ADDENDUM NO. 2

TO: PLANS AND SPECIFICATIONS FOR STATE OF MISSOURI

Campground Loop 5 – Electrical Improvements
Montauk State Park
Salem, Missouri
PROJECT NO. X2204-04

END ADDENDUM NO. 2

E-100

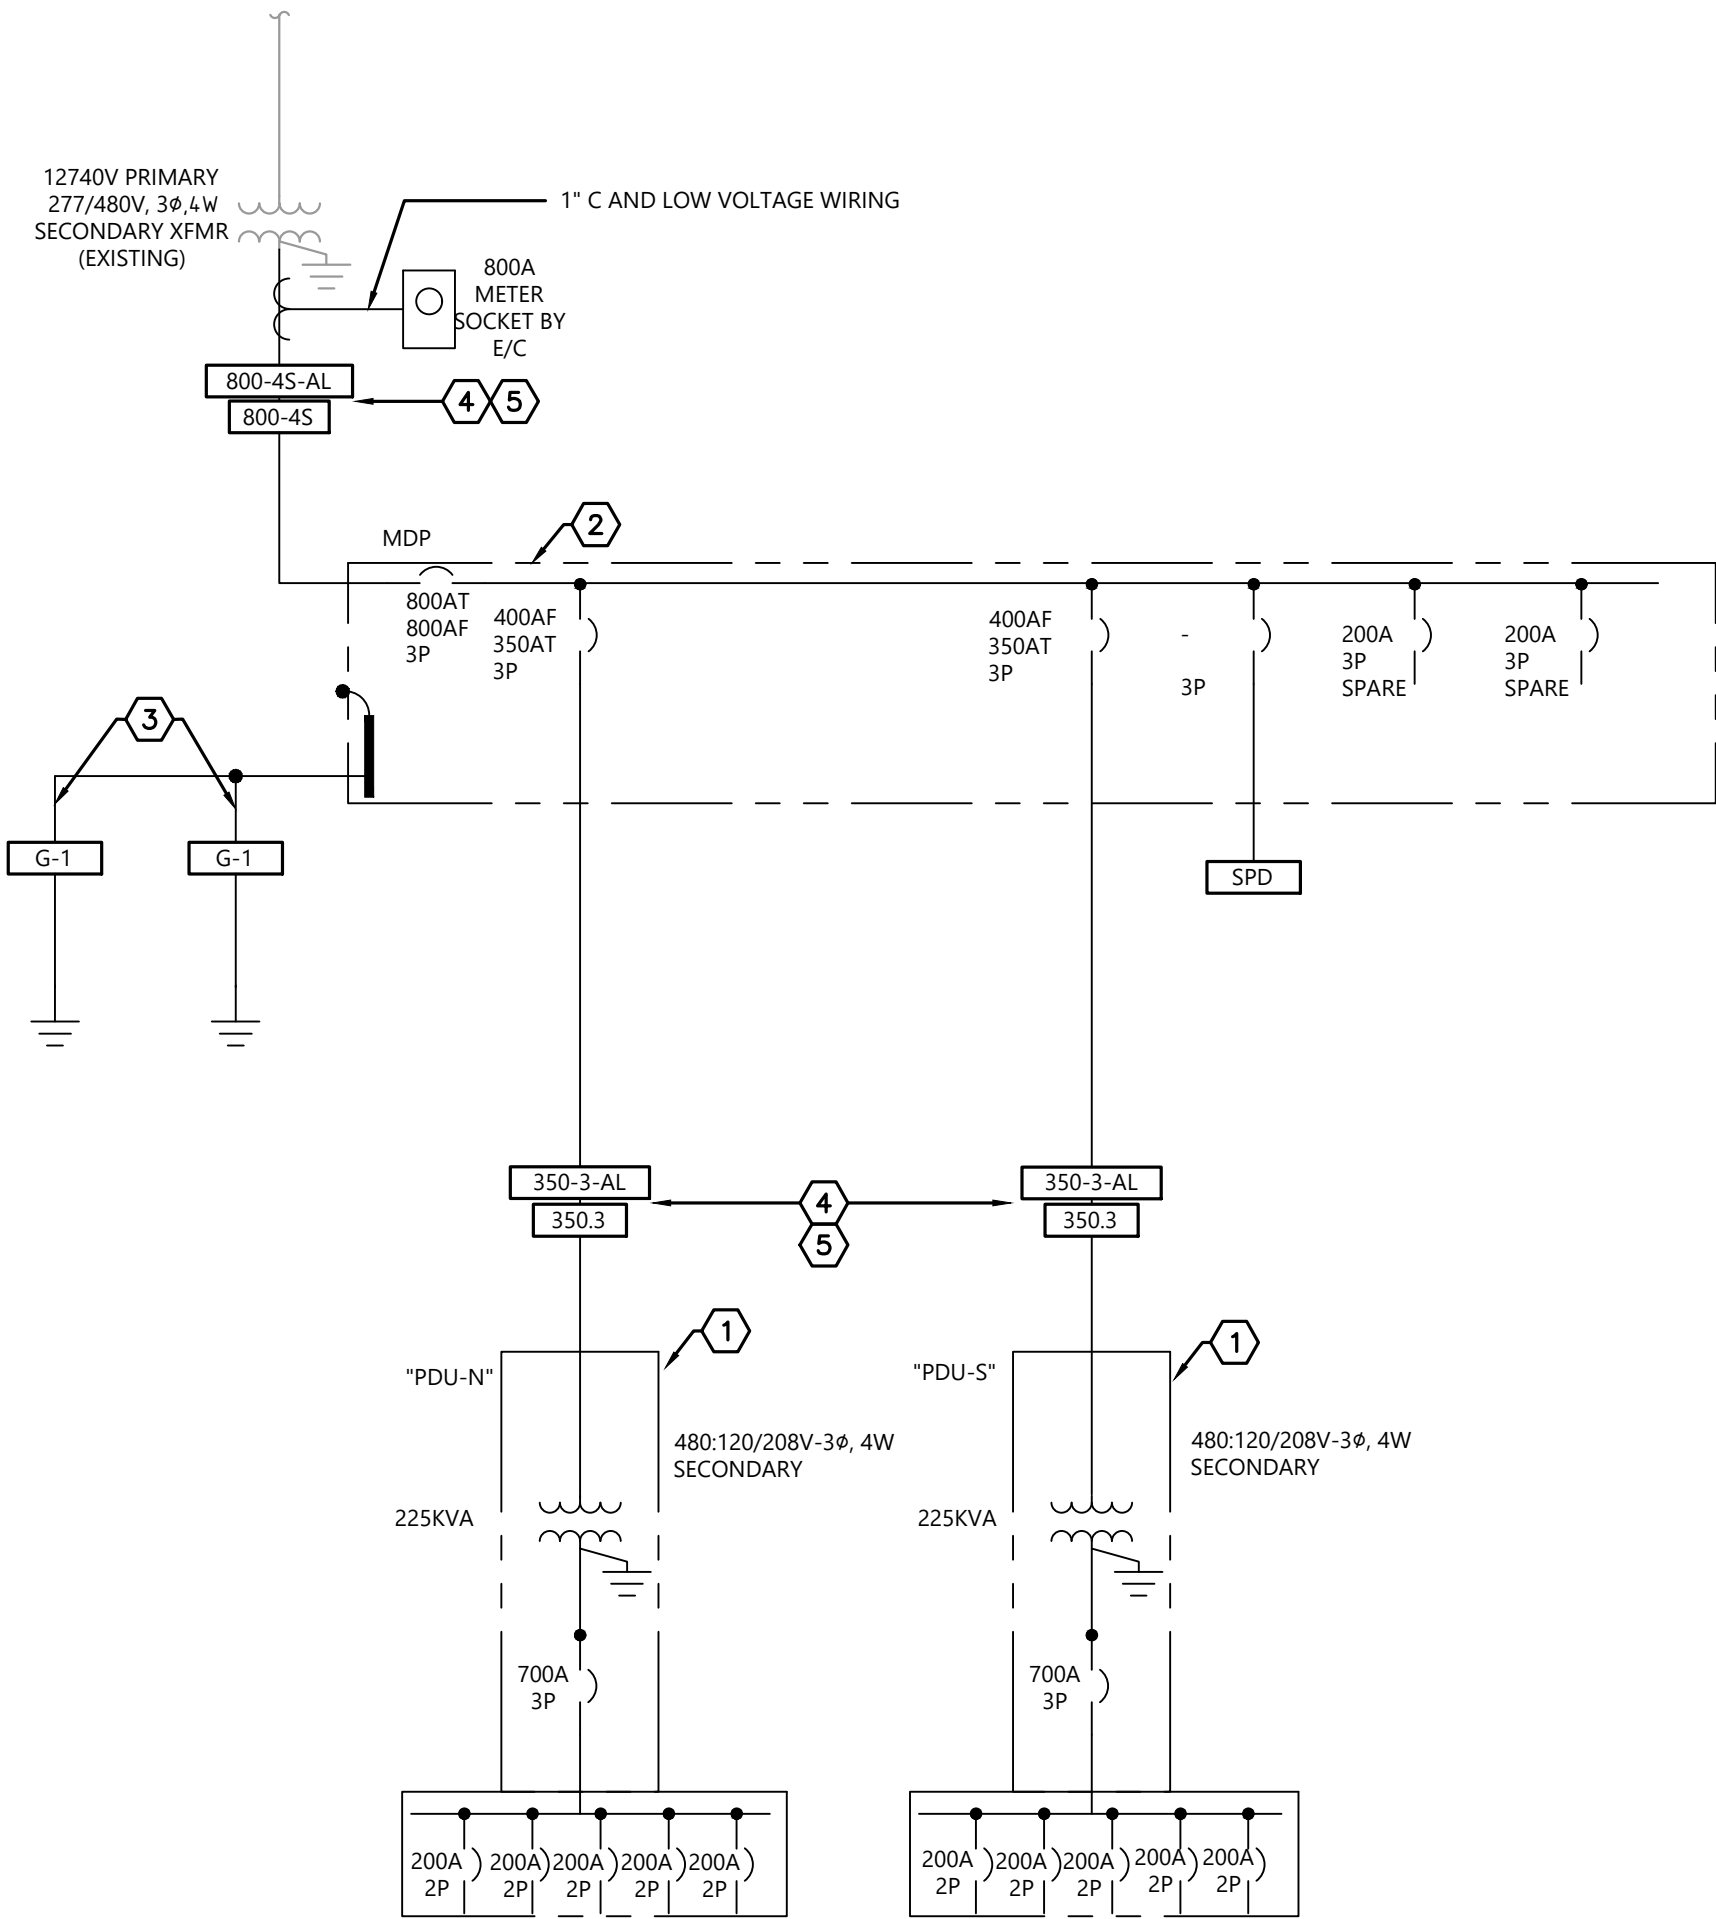
1. SHEET E-100
 - a. ADD General Note 7 to clarify conduit.
 - b. REVISE Branch Circuit Feeder Schedule #3 to allow AL wire.
 - c. REVISE Plan Note 1 to clarify conduit.
 - d. REVISE Plan Note 2 to clarify the addition of a new MDP.
 - e. REVISE Plan Note 3 to allow for separate transformer and Panelboard in leu of PDU
 - f. REVISE Plan Note 5 to clarify conduit.
 - g. REVISE Plan Note 6 to clarify conduit.
 - h. REVISE Plan Note 7 to clarify the addition of new RV pedestals.
 - i. ADD Plan Note 10 to clarify PDU-S scope of work.
 - j. ADD Plan Note 11 to clarify PDU-N scope of work.
2. SHEET E-300
 - a. REVISE One-Line Diagram Note #5 to clarify conduit.

7. STATE CREW WILL CLEAN AND/OR INSTALL AND TEST ALL CONDUIT NOTED FOR BRANCH CIRCUITS BELOW.

| 3 | (3)-#3/0 AND OR 250AL (1)-#6 OR #4 AL GROUND IN EXISTING 2.5" CONDUIT. |

| 1 | EXISTING UTILITY PAD MOUNTED TRANSFORMER. PROVIDE NEW CONDUIT AND CONDUCTORS AS REQUIRED. REFER TO ONE-LINE DIAGRAM. |
| 2 | EXISTING DISTRIBUTION BOARD. PROVIDE NEW MOUNT 800A, 277/480V, 3Ø, 4W, SERVICE ENTRANCE RATED DISTRIBUTION PANELBOARD ON UNISTRUT. RE: ONE-LINE DIAGRAM AND PANELBOARD SCHEDULE FOR INSTALLATION DETAILS AND TYPE. |
| 3 | PROVIDE PAD MOUNTED POWER DISTRIBUTION UNIT (PDU) WITH INTEGRAL SWITCHBOARD AND TRANSFORMER PER SCHEDULES. RE: DETAIL 6/E-400 FOR INSTALLATION DETAILS STRUCTURAL FRAME FOR EQUIPMENT IS EXISTING TO REMAIN. PROVIDE ADDITIONAL STRUCTURAL FRAME SUPPORT TO EXTEND PLATFORM TO PROVIDE 36" WORKING CLEARANCE IN FRONT OF GEAR. PROVIDE #3/0 GROUNDING TO STRUCTURAL FRAMING. ALTERNATELY ACCEPTABLE INSTALLATION SHALL BE SEPARATE TRANSFORMER AND PANELBOARDS, CLOSELY MOUNTED IN NEMA 3R ENCLOSURES. ALL PENETRATIONS BETWEEN CLOSE COUPLED SEPARATE EQUIPMENT SHALL MAINTAIN INTEGRITY OF ENCLOSURES. |
